ADDENDUM NO. 2

PROJECT NAME: SAPP Recreation Facility Renovation
UNL PROJECT NUMBER: C000P003
BID INVITATION NUMBER: 2301-14-7200

CONSULTANT: RDG Planning & Design
ADDRESS: 900 Farnam on the Mall, Suite 100
Omaha, NE 68102-5089

DATE OF ISSUANCE: February 7, 2014
DATE OF BID OPENING: Thursday, February 13, 2014
2:00 PM CT

2ED-2 Sheet E04.01 – Electrical Details and Schedules, Lighting Fixture Schedule:

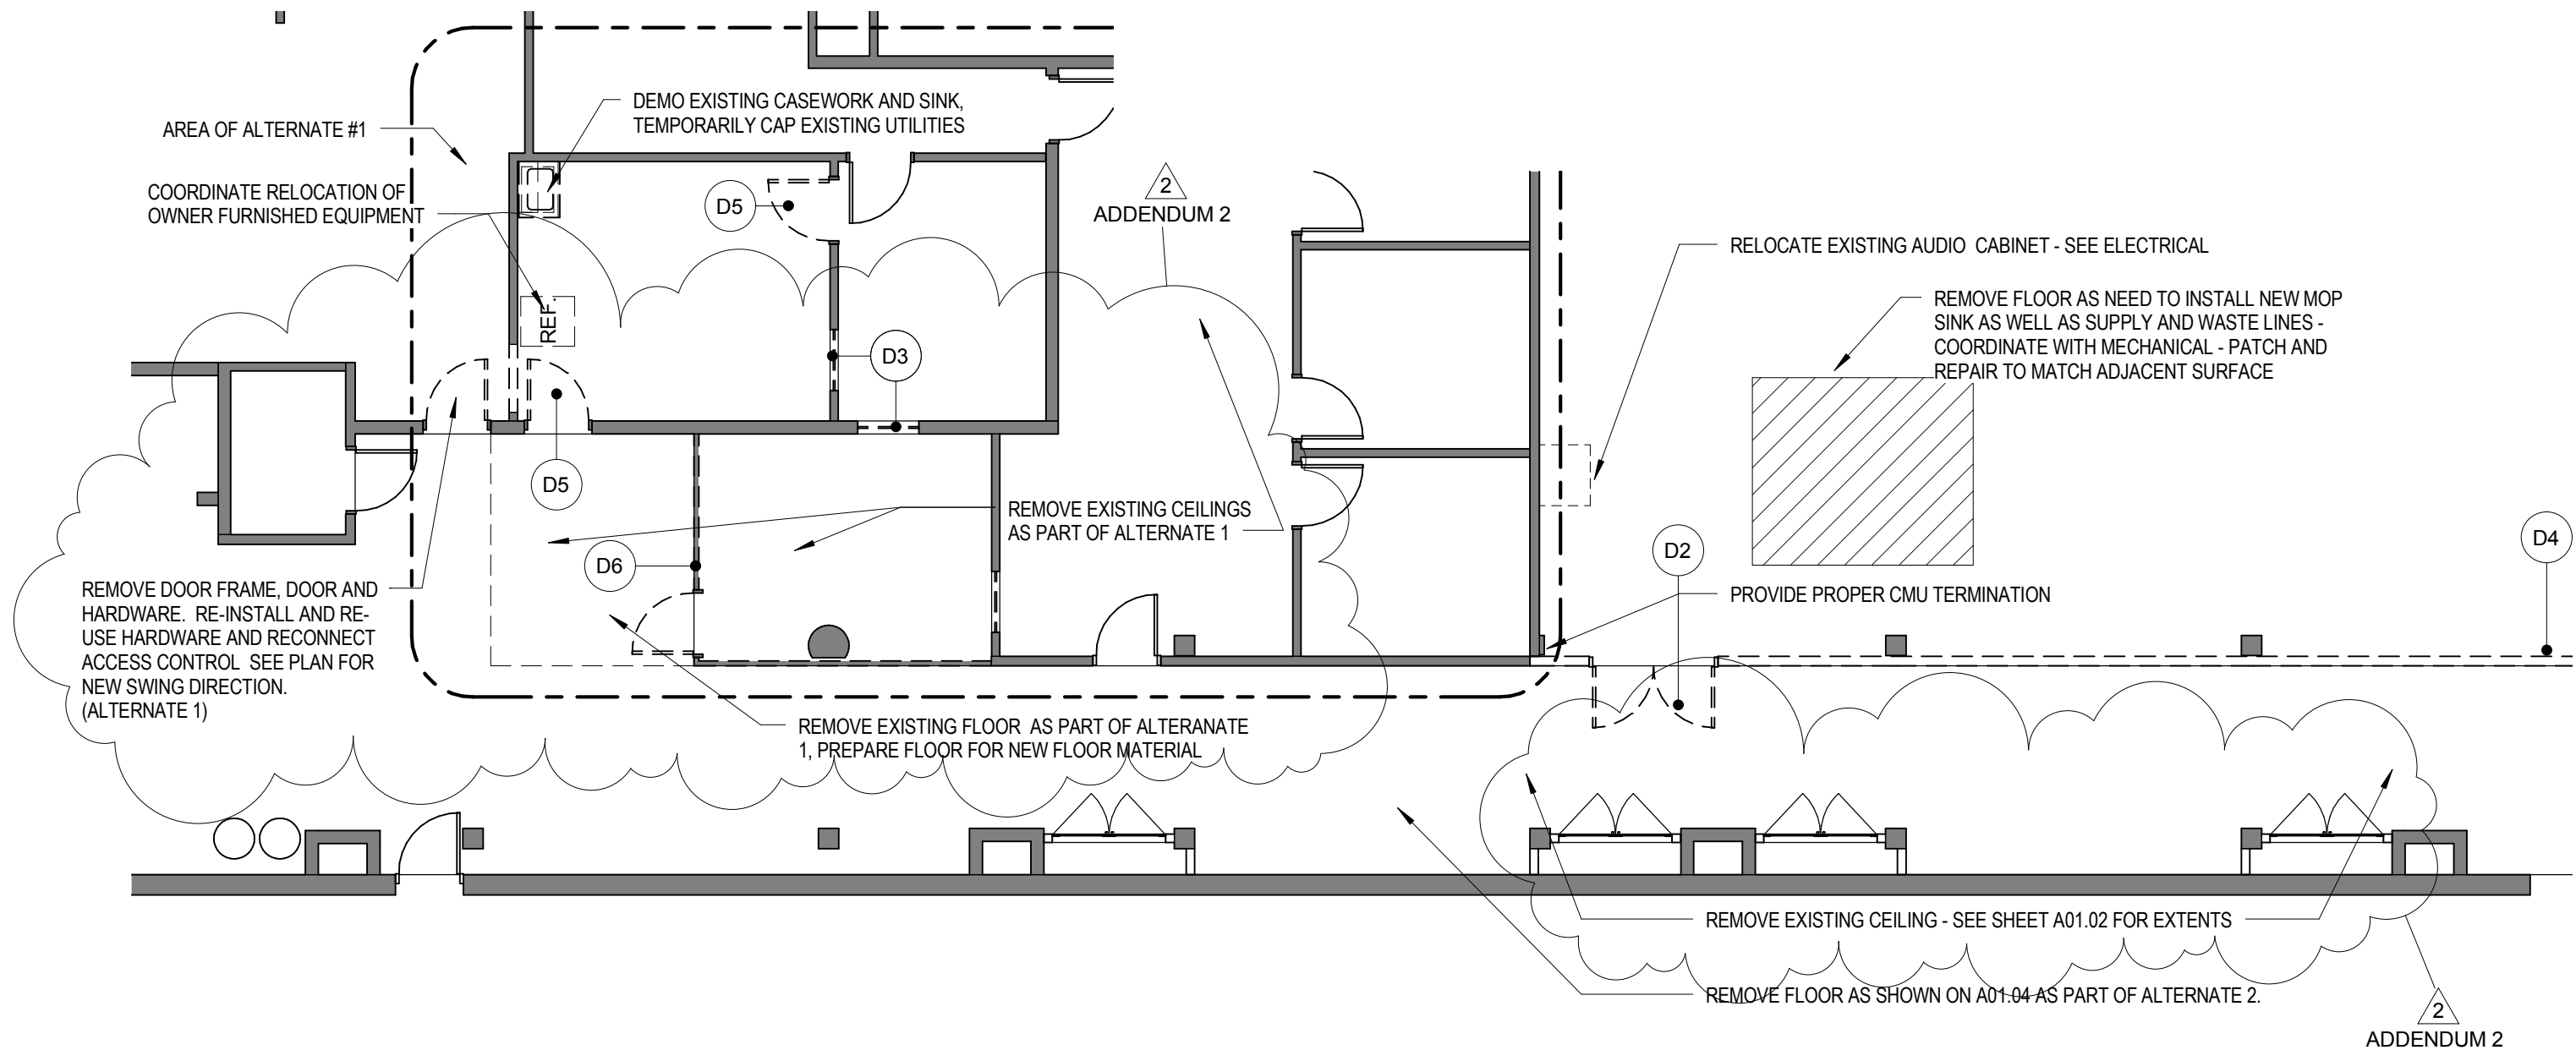
- A. Revise Note 4 to read as follows, “*Connect light fixture to inverter for emergency operation.*”
- B. The following lighting fixture manufacturers are considered equivalent for bidding purposes if equal to the specified lighting fixtures and are subject to final shop drawing review. Light fixtures may be rejected during the shop drawing review process if the Architect, Owner, or Engineer’s review does not find the submitted lighting fixture(s) to be equivalent.

Type:	Manufacturer:
1	<i>Fail-Safe</i>
2/2V	<i>Axis</i>
4	<i>Sure-Lites</i>
5	<i>Corelite</i>
6	<i>Sure-Lites</i>
7	<i>Metalux</i>
8	<i>Metalux</i>
9	<i>Metalux</i>

FIRST LEVEL FLOOR PLAN - DEMOLITION PLAN

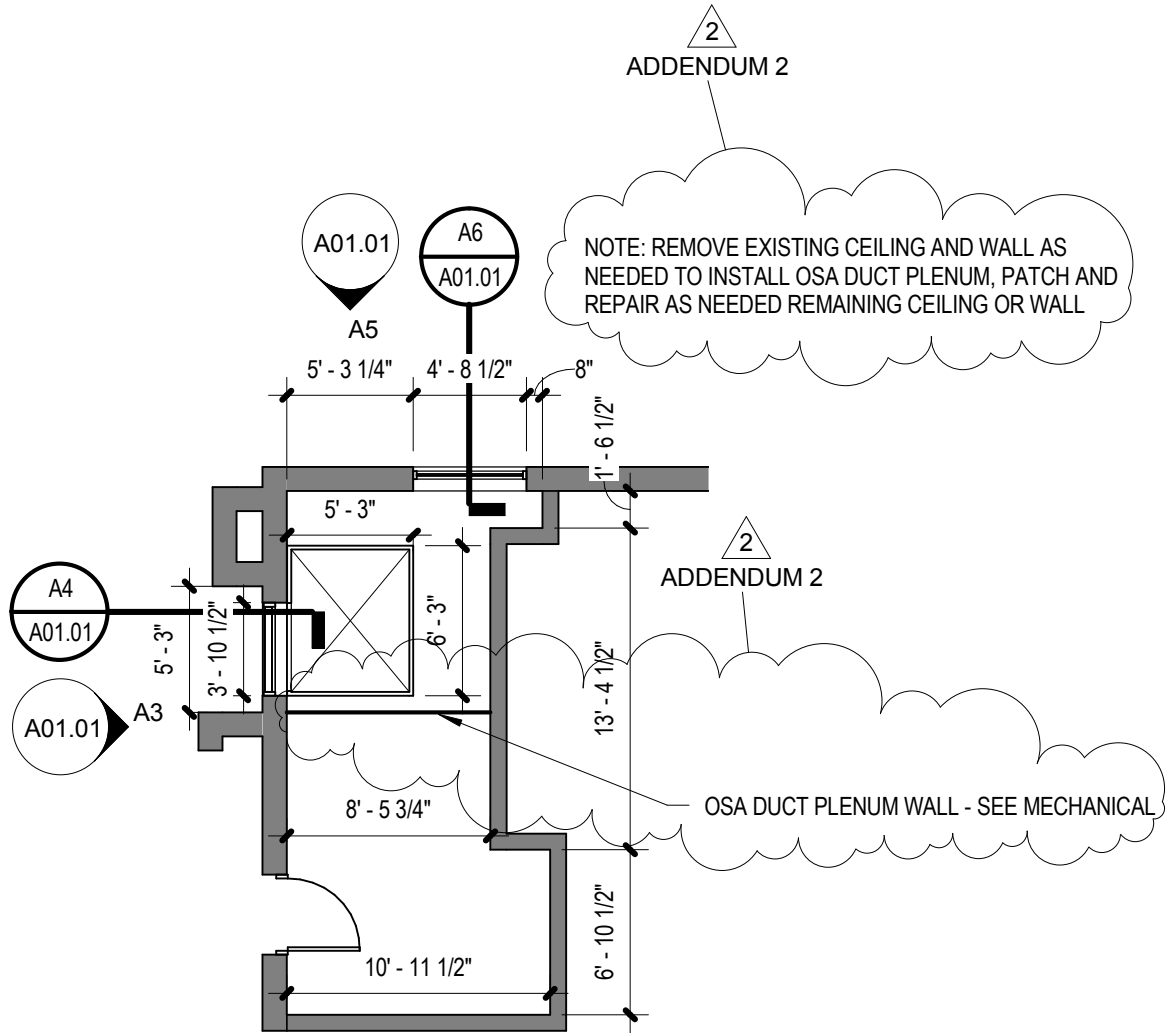
- 2PB-1 There was not any flooring demolition called out in the Alternate No. 1 area. Will the Contractor be responsible for flooring demolition? **Response: Yes, see Addendum 2. See Supplemental Drawing SDA-004.**

- 2PB-2 There was not any ceiling demolition shown. Will the Contractor be responsible for ceiling demolition? **Response: Yes, see Sheet A01.01 and Addendum 2. See Supplemental Drawing SDA-004.**

- 2PB-5 Alternate No. 1: At door on the north end, does the swing get changed as part of Alternate No. 1 or Base Bid? **Response: It will be included in Alternate No. 1; see Addendum 2. See Supplemental Drawing SDA-004.**

2GD-1 Sheet AD0.01 – First Level Floor Plan – Demolition Plan: Revise per attached Supplemental Drawing SDA-004. (Added notes for floor demolition in Alternate No. 1 area, as well as clarifies corridor ceiling demolition base bid.)

A2 EXISTING STORAGE PLAN

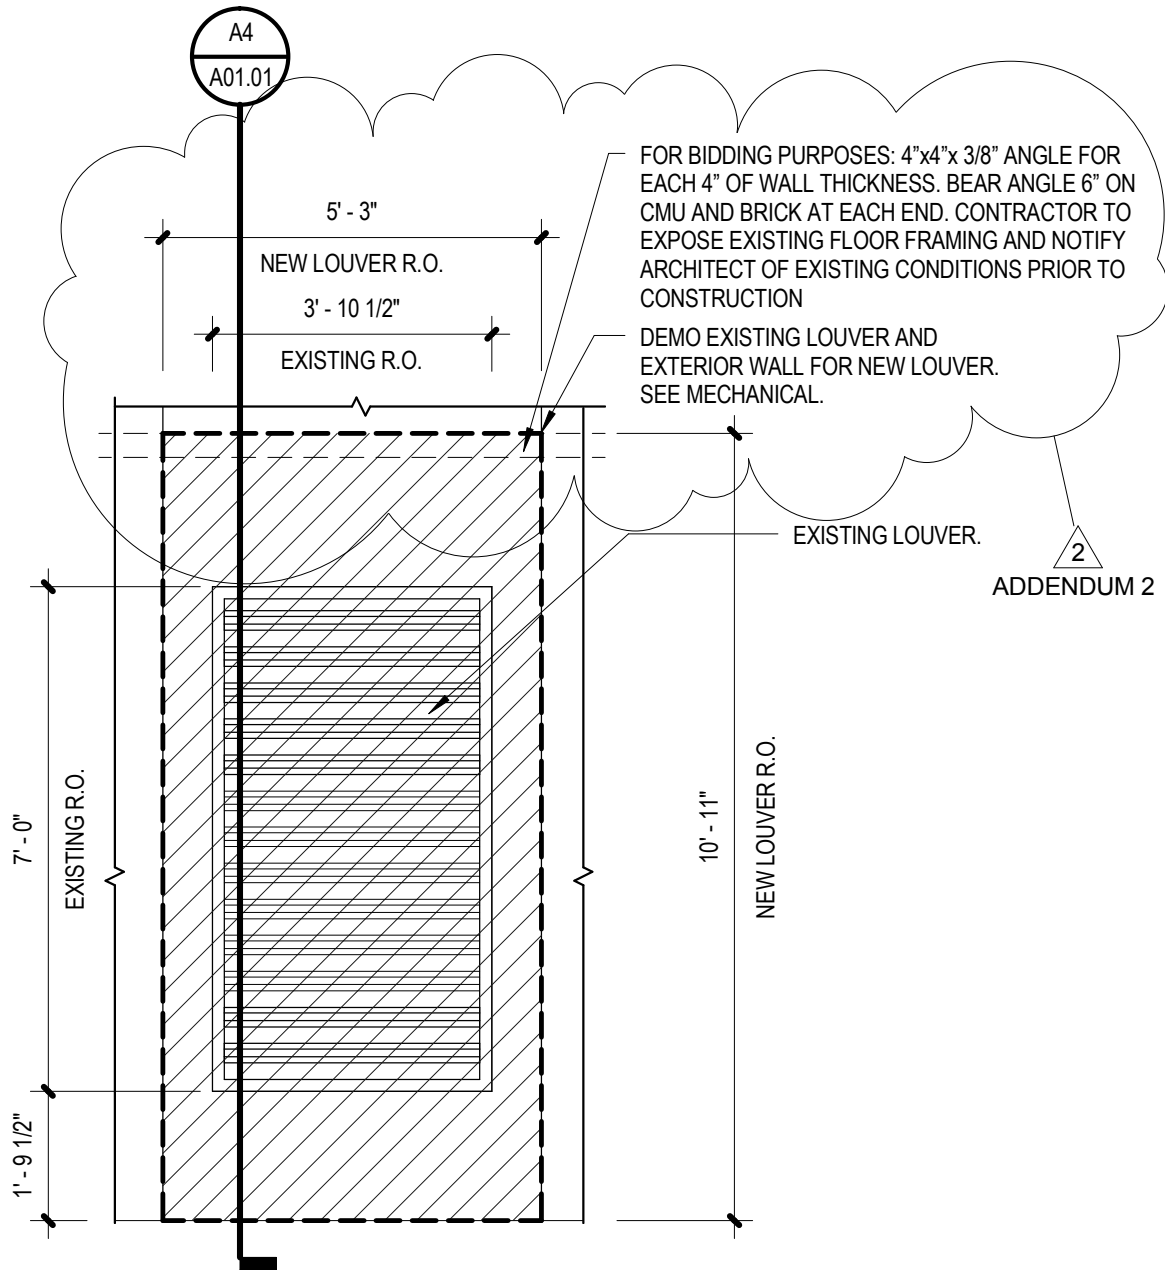
- A. Revise Detail A2 per attached Supplemental Drawing SDA-005. (Clarifies extent of OSA plenum in coordination with Mechanical Plans.)
- B. Revise Detail A3 per attached Supplemental Drawing SDA-006. (Identifies for bidding purposes lintel size and location.)
- C. Revise Detail A4 per attached Supplemental Drawing SDA-007. (Identifies for bidding purposes lintel size and location.)

EXISTING LOUVER ELEV.

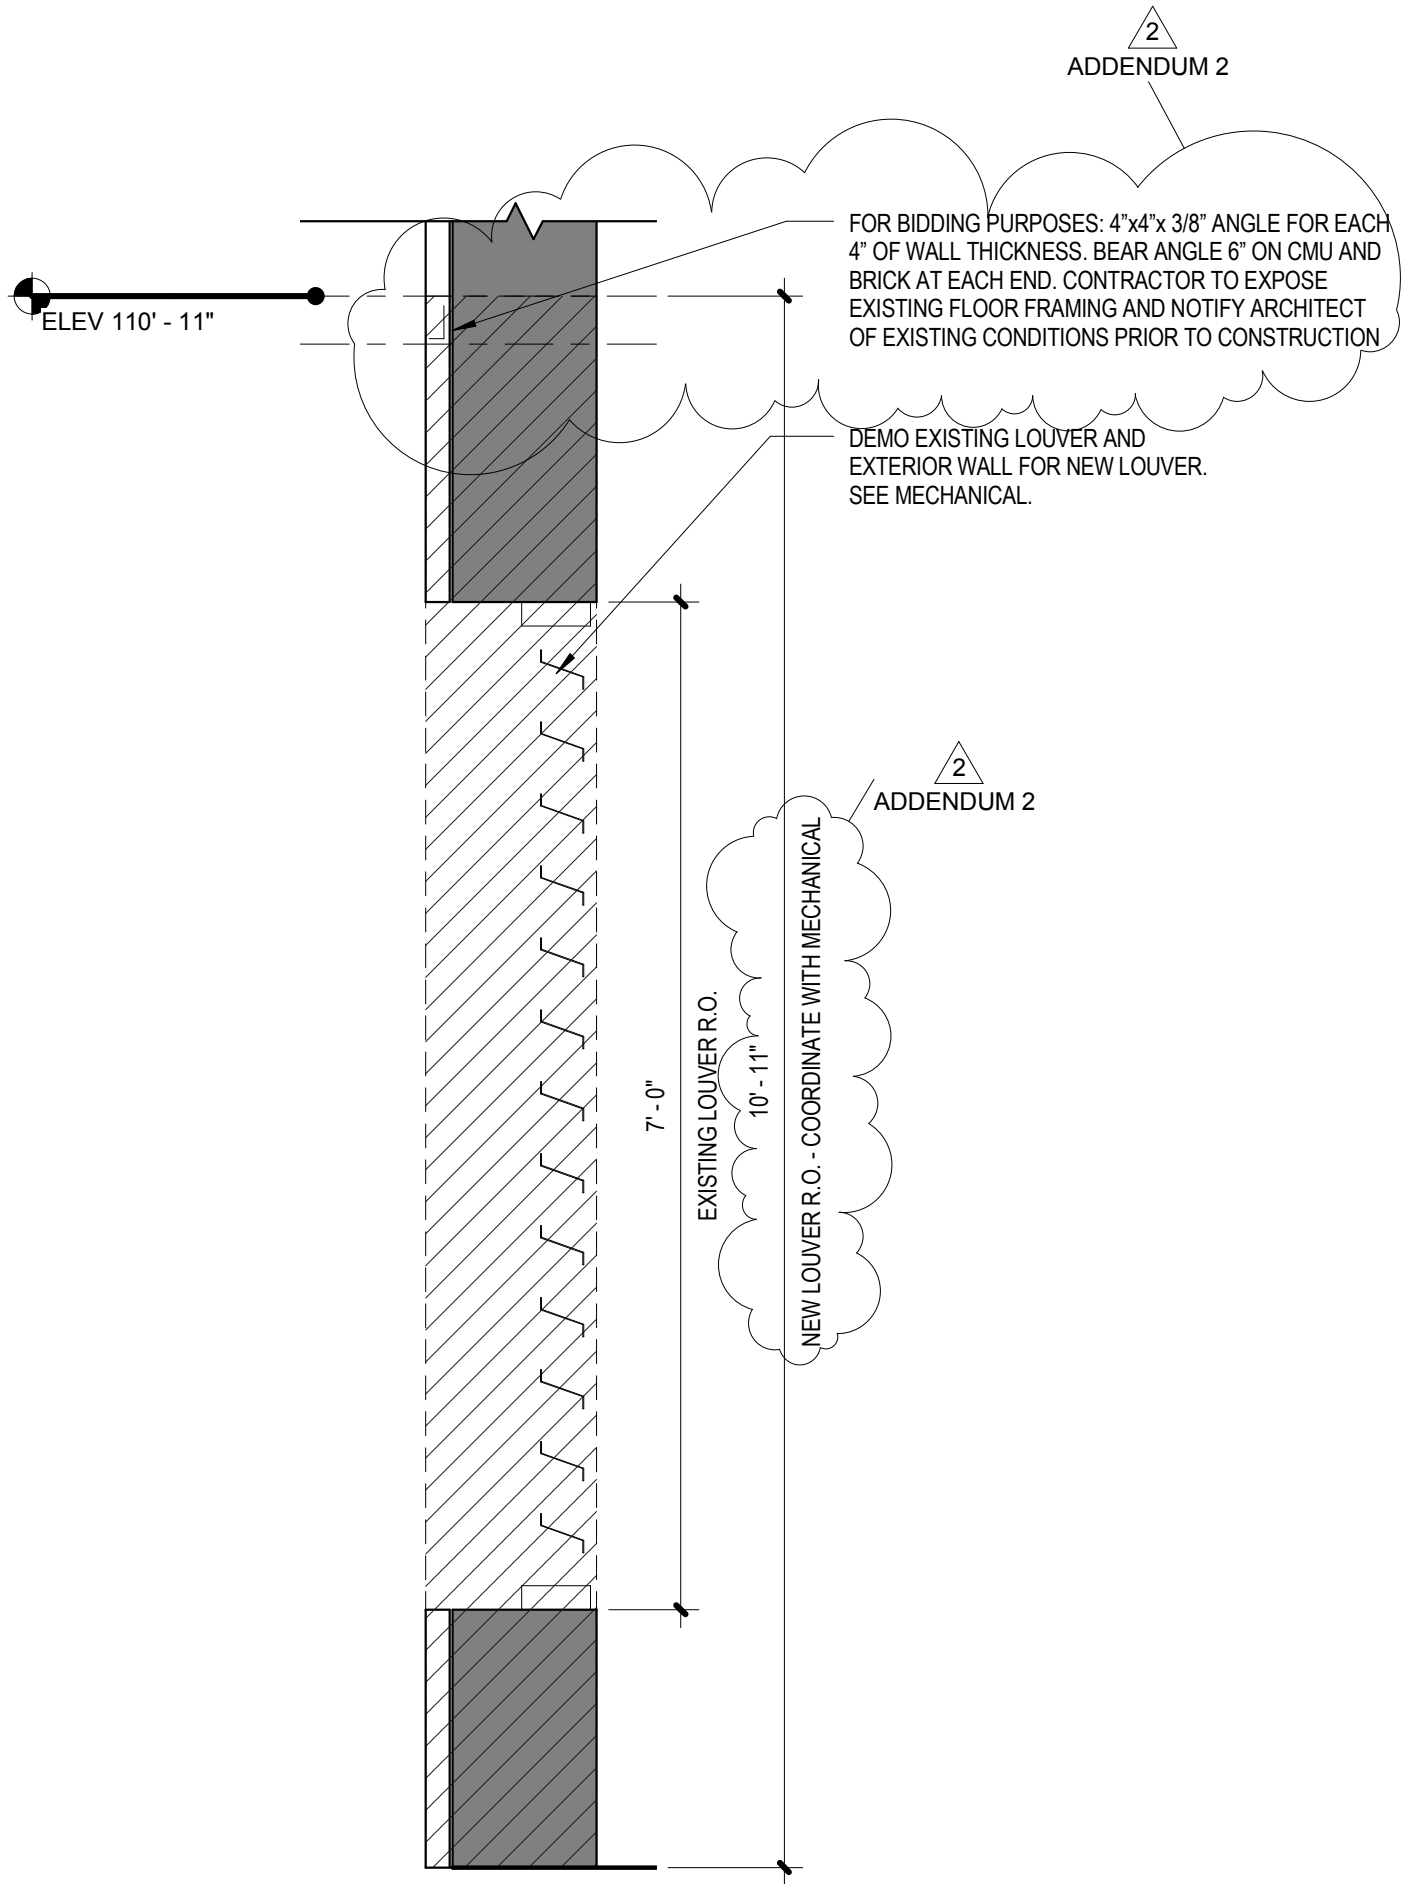
- 2PB-7 Is a new lintel required at the opening that is being made larger for the new louver described in Details A3 and A4 on Sheet A01.01? If so, can you specify what will be needed? **Response: See Addendum 2. See Supplemental Drawings SDA-006 and SDA-007.**
